**PART AFFECTED:** TP164386 Magnet Mounting Bracket

**CHANGE:** The manufacturing process for the TP164386 magnet mounting bracket is revised to eliminate the substance that causes the armature to hang up.

**TP164386 MAGNET MOUNTING BRACKET**

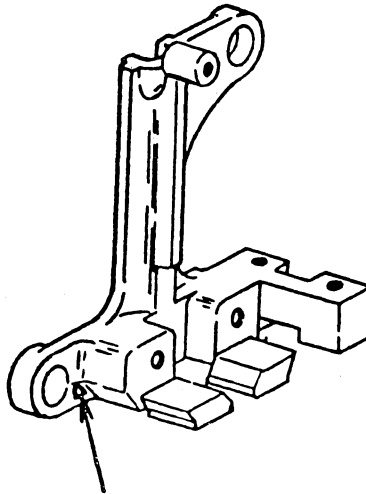
**IDENTIFICATION:** The TP164386 magnet mounting brackets manufactured by the revised process can be identified by the presence of a blue dot near the lower mounting hole. See Attachment Sheet 1.

**BLUE DOT IN THIS AREA INDICATES  
TP164386 MAGNET MOUNTING BRACKET  
MANUFACTURED BY THE REVISED PROCESS.**
